CITY PLAN COMMISSION**THURSDAY, January 15, 2026****FILE NUMBER:** PLAT-25-000169**SENIOR PLANNER:** Hema Sharma**LOCATION:** James Temple Drive at Preston Road/State Highway No. 289, northwest corner**DATE FILED:** December 19, 2025**ZONING:** PD 887 (Subdistrict 1C, WMU-12)**PD LINK:** <https://dallascityhall.com/departments/city-attorney/Articles/PDF/Article%20887.pdf>**CITY COUNCIL DISTRICT:** 11**SIZE OF REQUEST:** 2.927-acres**APPLICANT/OWNER:** Midtown Premier Owner LLC

REQUEST: An application to replat a 2.927-acre tract of land containing portion of Lot 3 in City Block A/7409 to create one lot on property located on James Temple Drive at Preston Road/State Highway No. 289, northwest corner.

PLAT-25-000169

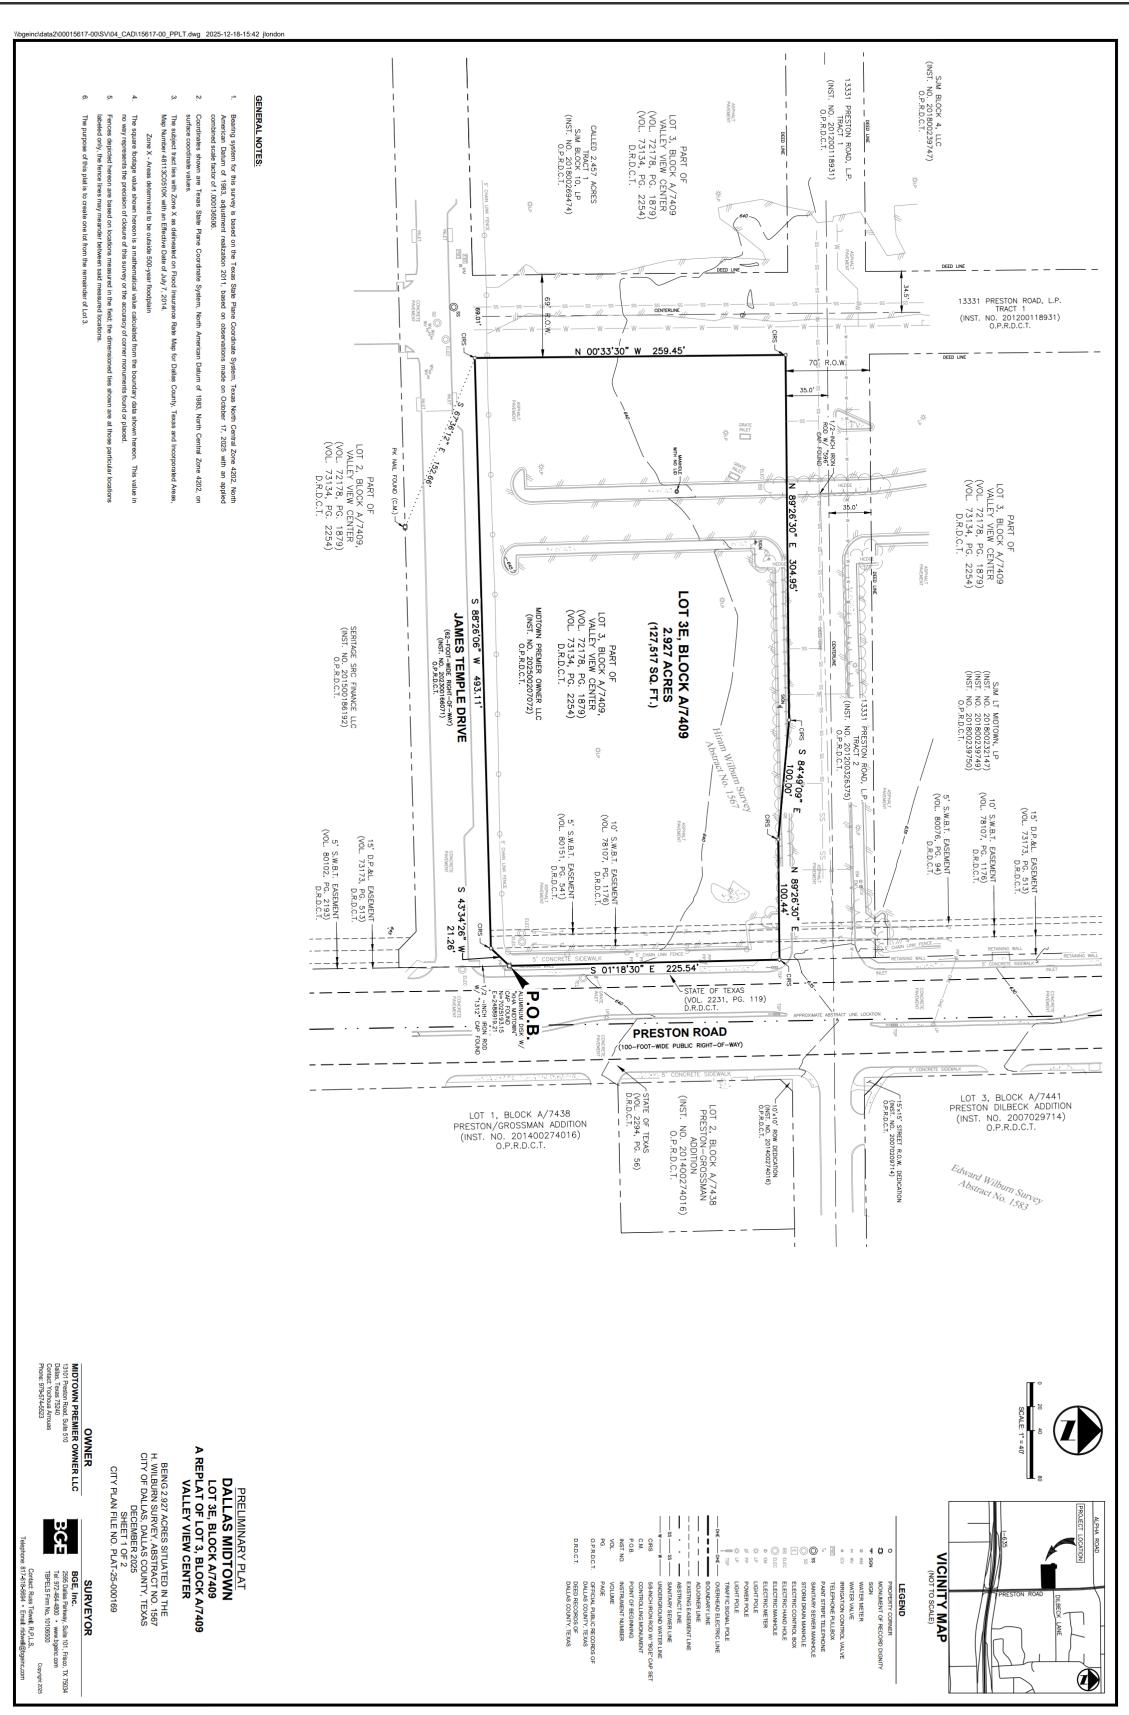
1. The final plat must conform to all requirements of the Dallas Development Code, Texas Local Government Code, Texas Land Surveying Practices Act and the General Rules and Regulations of the Texas Board of Land Surveying.

2. Department of Development Services, Engineering Division must verify that the plat conforms with the water, wastewater, and easement requirements under the provisions of Chapter 49 of the Dallas City Code.

3. Compliance with all plans, contracts, ordinances, and requirements of the City of Dallas. *Section 51A-8.102(a), (b), (c), and (d)*
4. The number and location of fire hydrants must comply with the Dallas Fire Code.

5. Any new or existing structure may not extend across new property lines. *Section 51A-8.503(e)*
6. On the final plat, all easement abandonments, and ROW abandonments must be by separate instrument with the recording information shown on the face of the plat. A release from the Real Estate Division is required prior to the plat being submitted to the Chairman for signature.

7. On the final plat, include two boundary corners tagged with these coordinates: "Texas State Plane Coordinate System, North Central Zone, North American Datum of 1983 on Grid Coordinate values, No Scale and no Projection."

8. On the final plat, monument all set corners per the Monumentation Ordinance. Prior to submittal of the final plat for the Chairman's signature. The monuments must be verified by the Chief City Surveyors Office in the Public Works Department. *Section 51A-8.617*
9. Provide ALL supporting documentation (i.e. deeds, plats, ordinances, easements...etc) with a completed Final Plat Checklist to the Survey Plat Review Group (**SPRG**) with the Final Plat Submittal after City Plan Commission Approval.
10. Prior to the final plat, submit a tree survey to the Arborist. A release from the arborist is required prior to an early release request or the recordation of the plat, whichever occurs first.
11. The number of lots permitted by this plat is one.

12. Submit a full set of Civil Engineering Plans (drainage, paving, street signage/marking/lighting) prepared per City Standards by a licensed (TX) Professional Engineer to Engineering Division in Room 200, Oak Cliff Municipal Center (i.e. 311T/DP). Additions and alterations to the public infrastructure require approval and may require private development contracts with bonds.51A- 8.102 (c); 8.601(b)(4),(5),(6),(7),(8),(9)
13. Detention may be required if the capacity of available outfall is not adequate to carry the developed runoff. *Section 51A-8.611(c)*.
14. "Lot-to-Lot drainage will not be allowed without proper City of Dallas Engineering Division approval" (Note must be on the Plat). *51A 8.611(e)*

15. Preston Road/State Highway No. 289 is on the City of Dallas Thoroughfare Plan and classified as a Community Collector with SPCL 6D which requires 112 feet of ROW (or 56 feet from established centerline.)
16. Dedicate a minimum 20 x 20 corner clip (via Fee Simple or Street Easement) at intersection of Preston Road/State Highway No. 289 and Dilbeck Lane per 51A 8.602(d)(1).
17. A larger corner clip may be requested during engineering plan and traffic review to accommodate an adequate turning radius, or to maintain public/traffic appurtenances, within the area of the corner clip. *51A 8.602(d)(1), 51A 8.608(a)*
18. Plans must comply with Citys street lighting standards. See illumination standards in Street Design Manual.
19. Plans must comply with sidewalk design standards: sidewalks must comply with a minimum five-foot width plus five-foot buffer.

20. Prior to final plat, submit a completed final plat checklist and all supporting documents.

21. On the final plat, show how all adjoining right-of-way was created. Section 51A-8.403(a)(1)(A)(xxii).
22. On the final plat, show recording information on all existing easements within 150 feet of the property.
23. On the final plat, show all additions or tracts of land within 150 feet of the property with recording information. Platting Guidelines.

24. Additional design information is required for assessment. Site plan must be submitted showing proposed development, building finished floor elevation, development, existing mains – including downstream manhole, and proposed water and wastewater service locations. Submit water/wastewater engineering plans to 320 E. Jefferson Blvd., Room 200, Attention: Water and Wastewater Engineering.
25. Wastewater main improvements is required by Private Development Contract. Submit water/wastewater engineering plans to 320 E. Jefferson Blvd., Room 200, Attention: Water and Wastewater Engineering.

26. Additional design information needed to complete review. Provide a brief description of the proposed project and a copy of the site plan to daniel.silva1@dallas.gov to determine street lighting requirements.
27. On the final plat, change "Preston Road" to "Preston Road/State Highway No. 289". Section 51A-8.403(a)(1)(A)(xii).
28. On the final plat, add "Dilbeck Lane".
29. On the final plat, identify the property as Lot 3B in City Block A/7409.
